901 NORTH CAPITOL STREET NE ZONING COMMISSION SUBMISSION

PREVIOUSLY APPROVED - ZC CASE NO. 21-09

901 NORTH CAPITOL STREET NE ZONING COMMISSION SUBMISSION : JUNE 16, 2023

WEST BUILDING RENDERING : A09 - REV

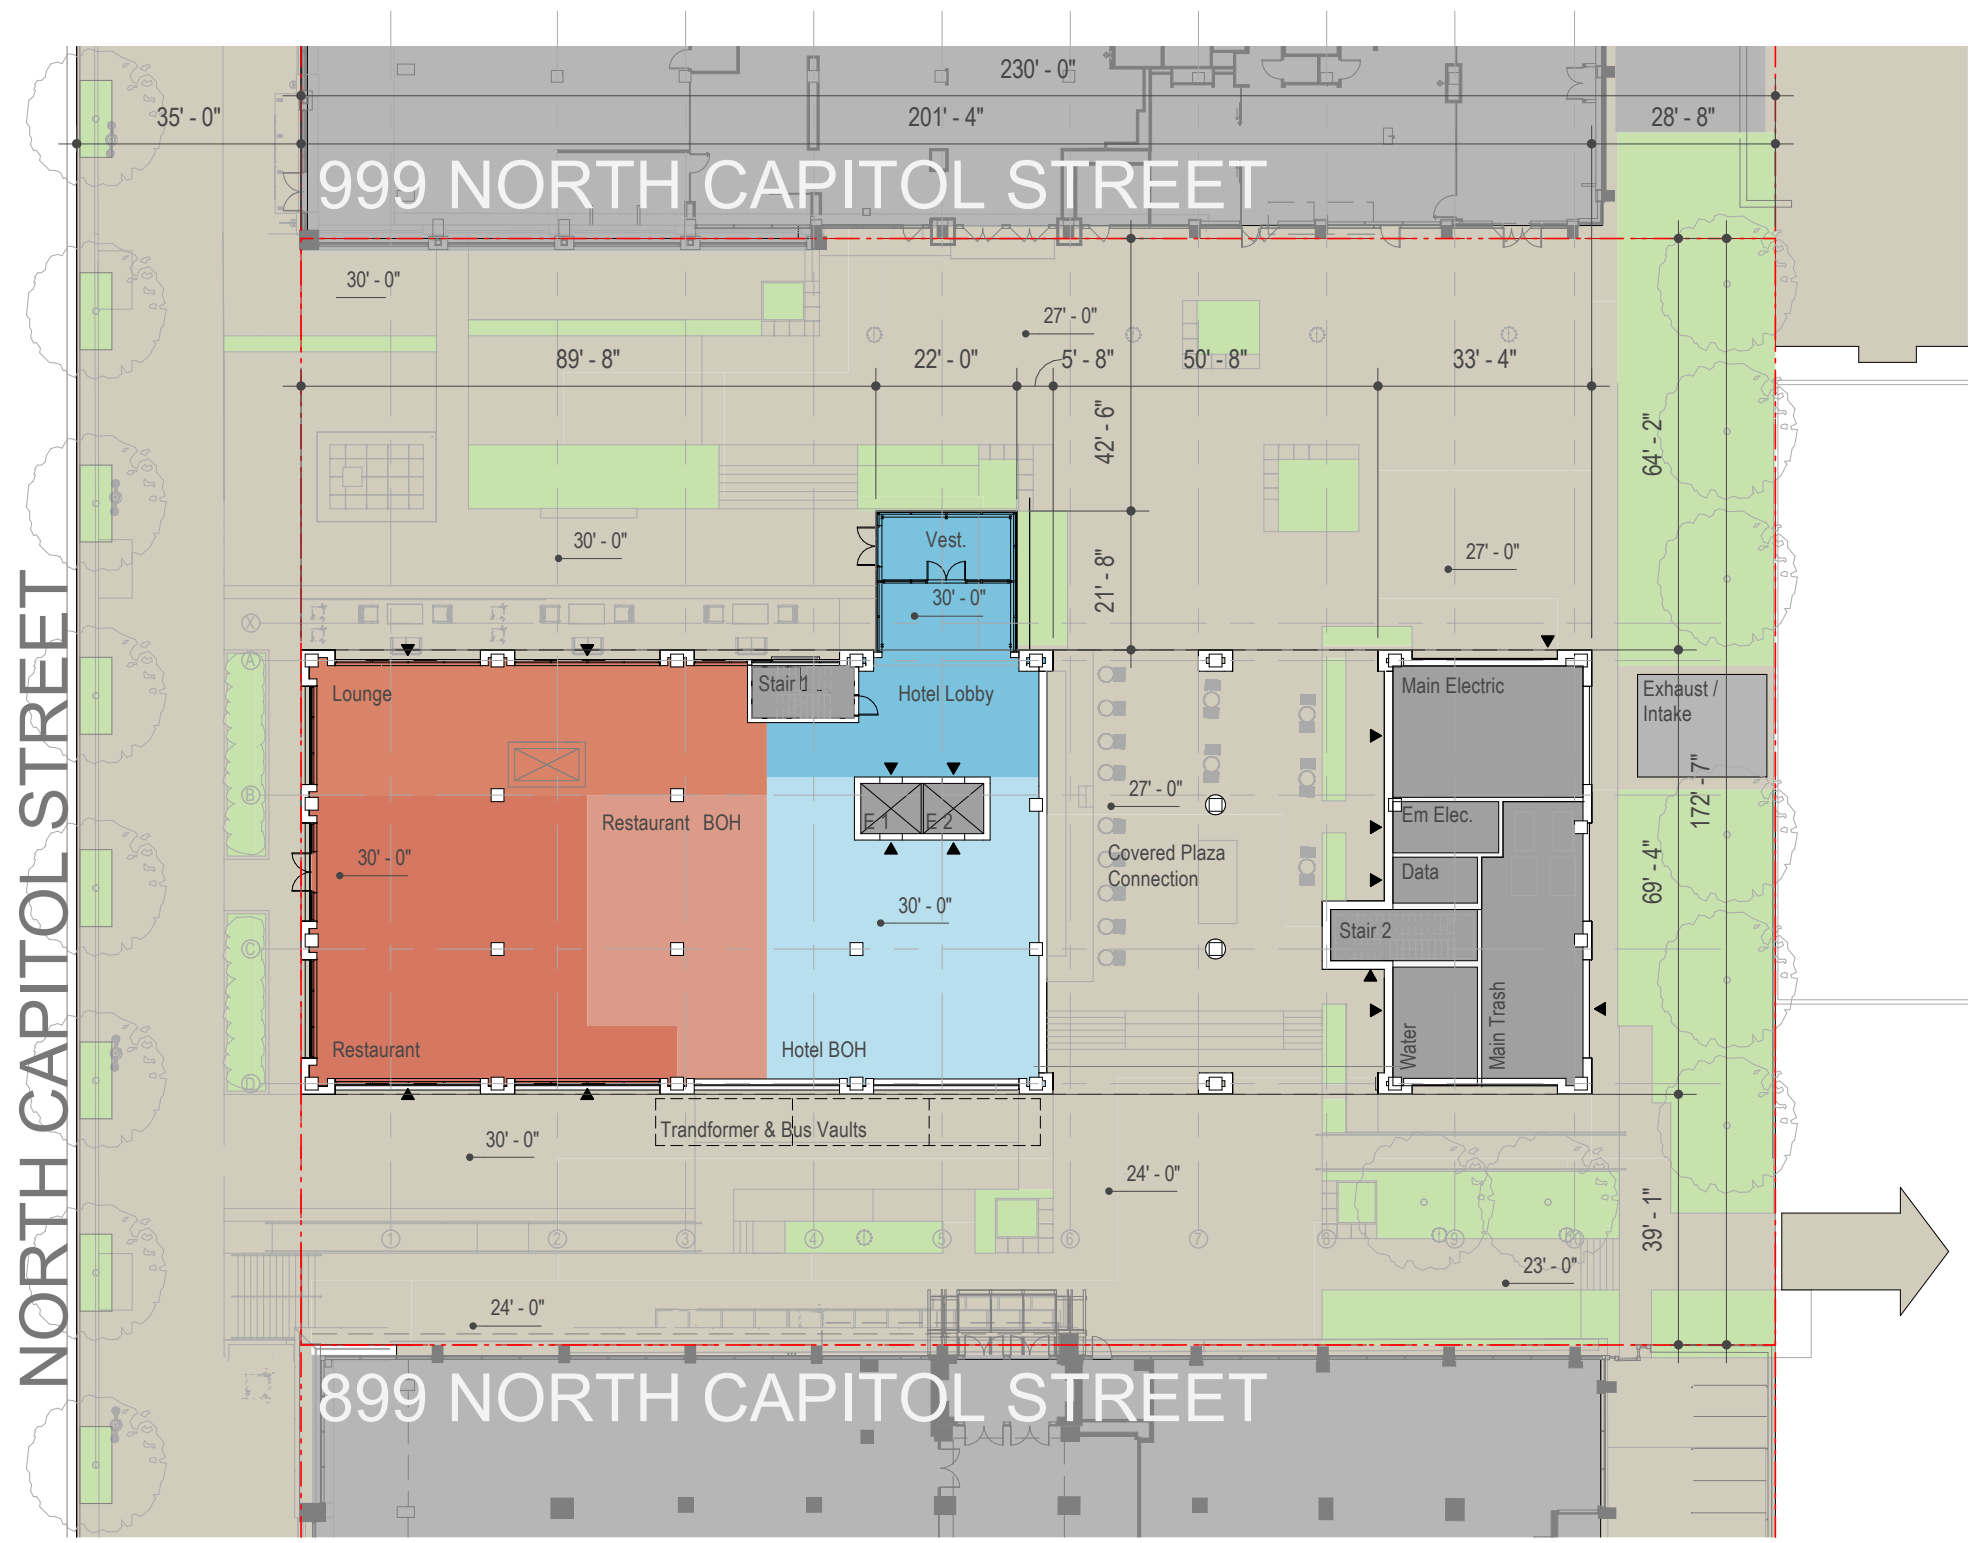
AREA OF MODIFICATON:
WINDOWS UPDATED TO TWO SIDE
BY SIDE SINGLE HUNG WINDOWS

AREA OF MODIFICATION:
STOREFRONT UPDATED: FIXED
WITH LOWER OPERABLE WINDOWS

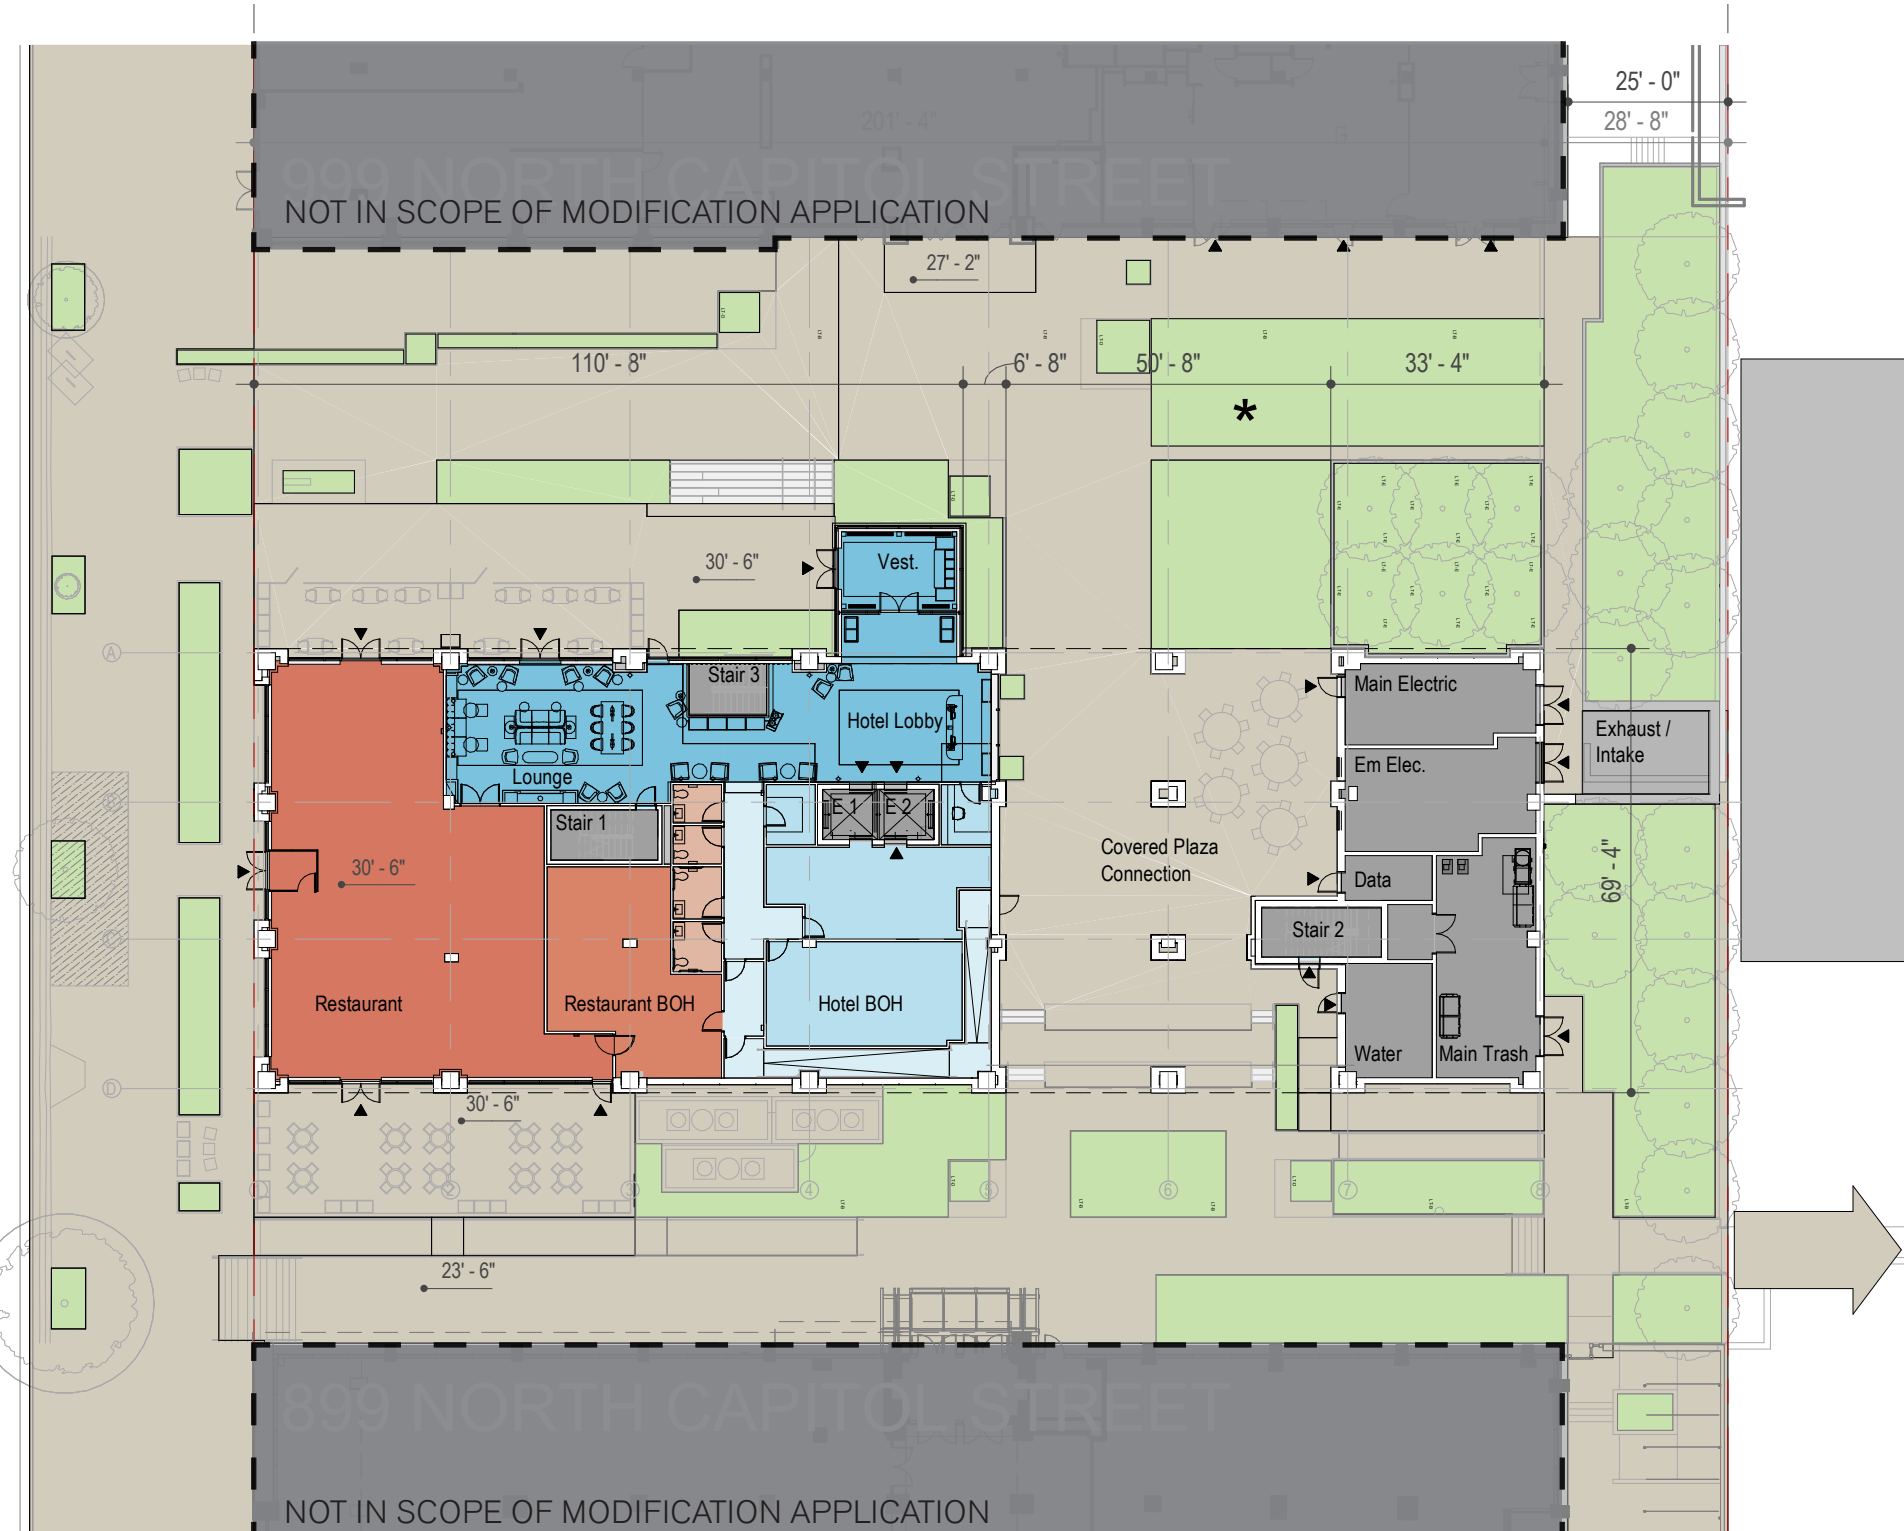
AREA OF MODIFICATION:
STAIR 1 RELOCATED, STAIR 3 INTRODUCED,
RETAIL & HOTEL BOH LAYOUT UPDATED,
SERVICE RAMP INTRODUCED AND NEW
DOOR INTRODUCED IN COVERED PLAZA,
LANDSCAPE UPDATED.

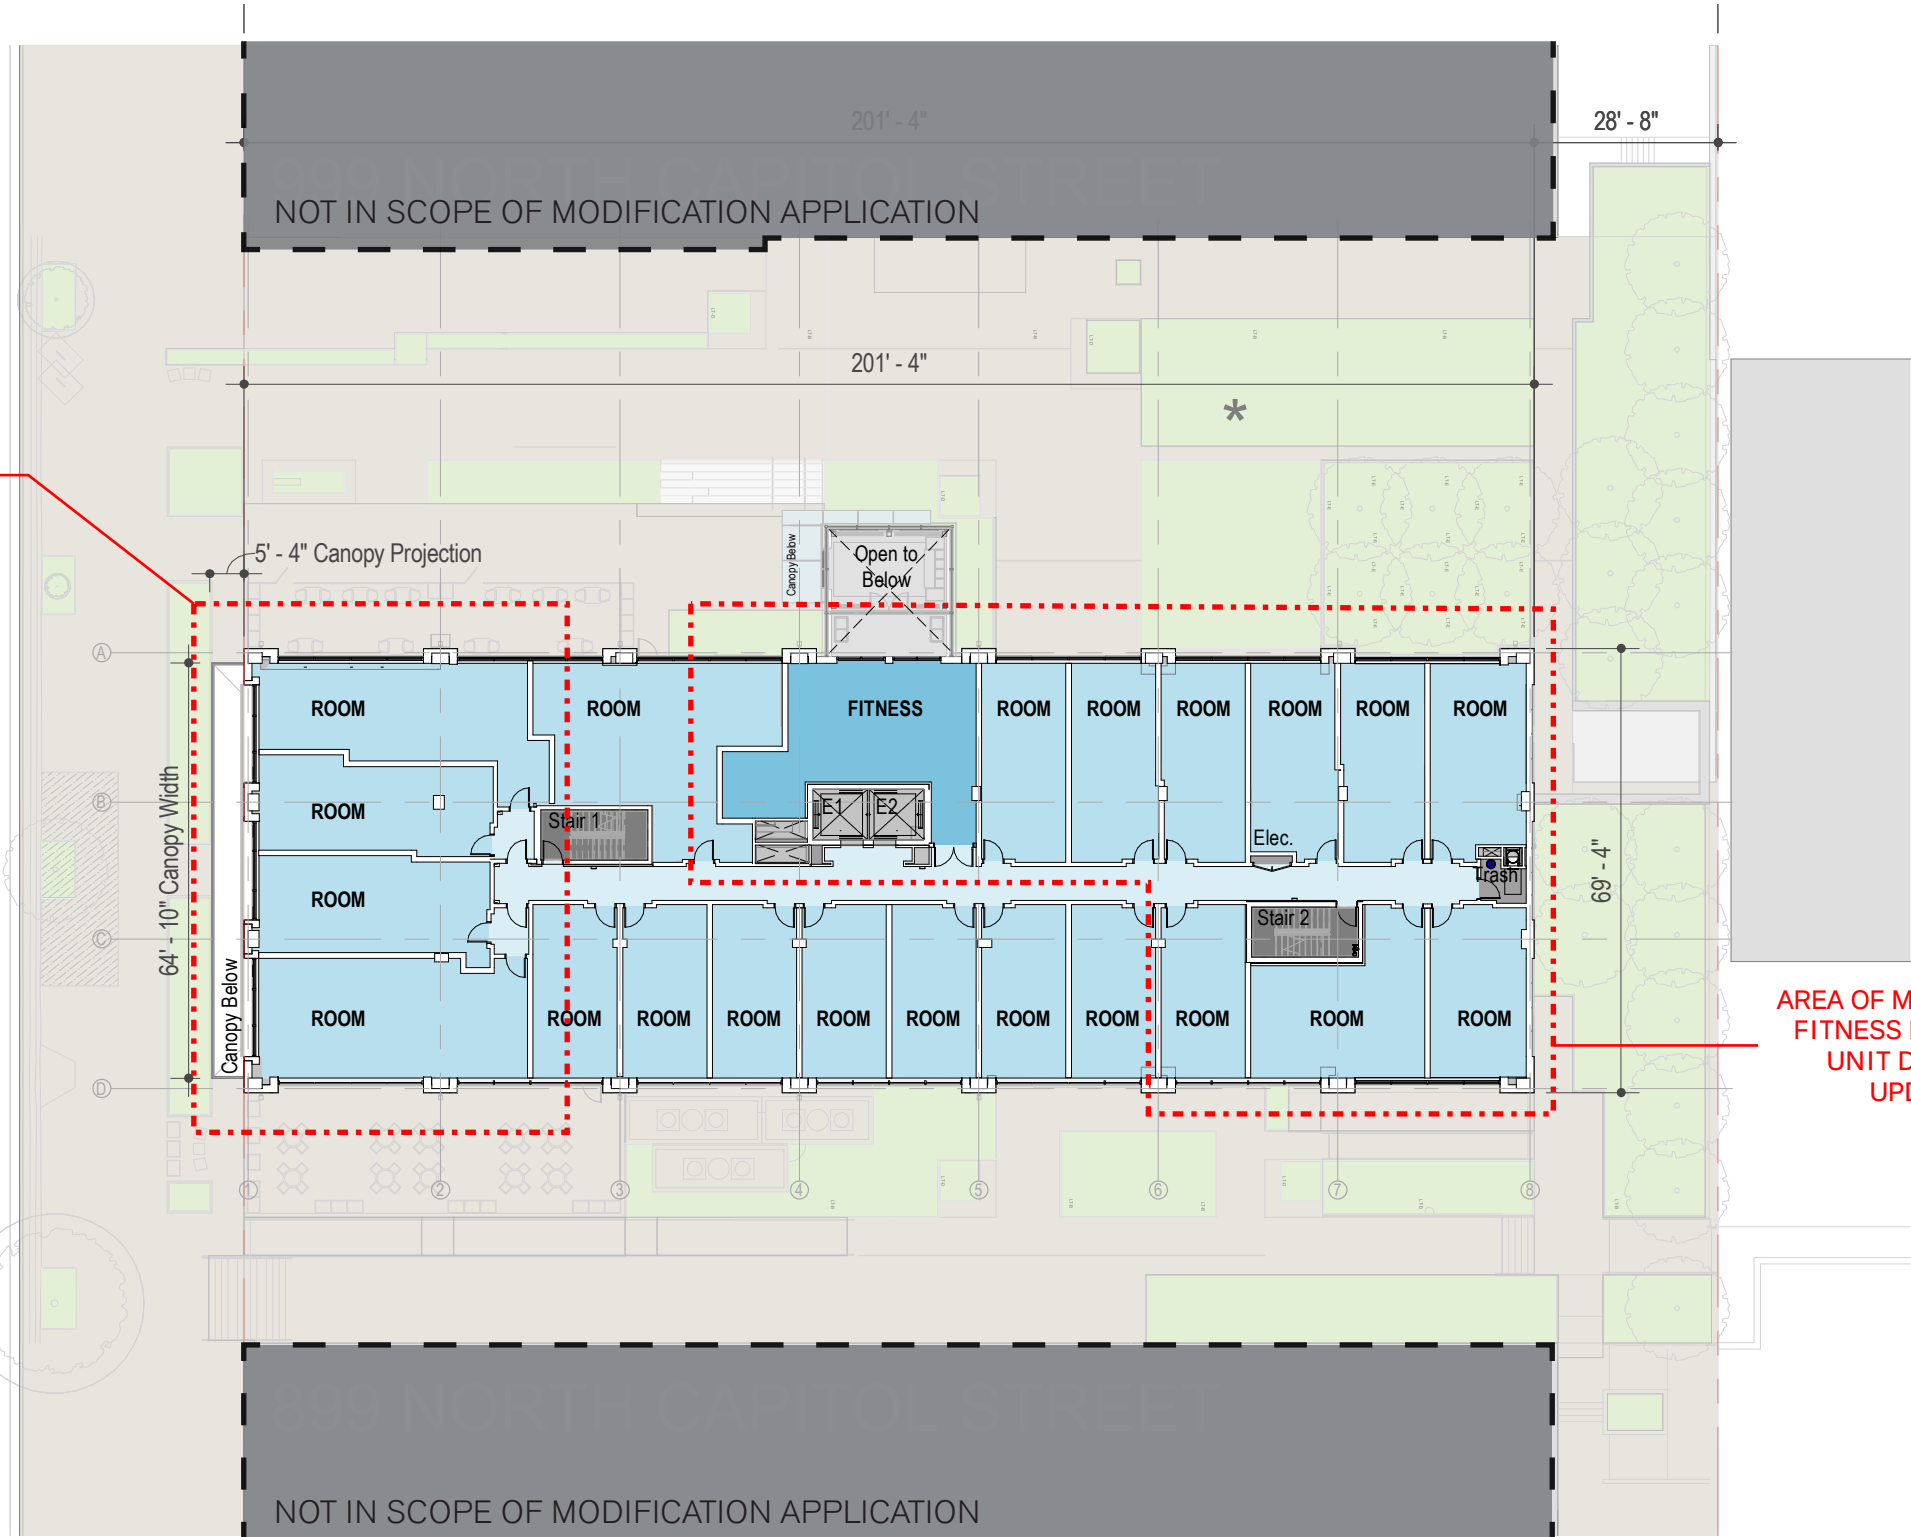
AREA OF MODIFICATION:
RETAIL SPACE REMOVED,
REPLACED BY HOTEL ROOMS
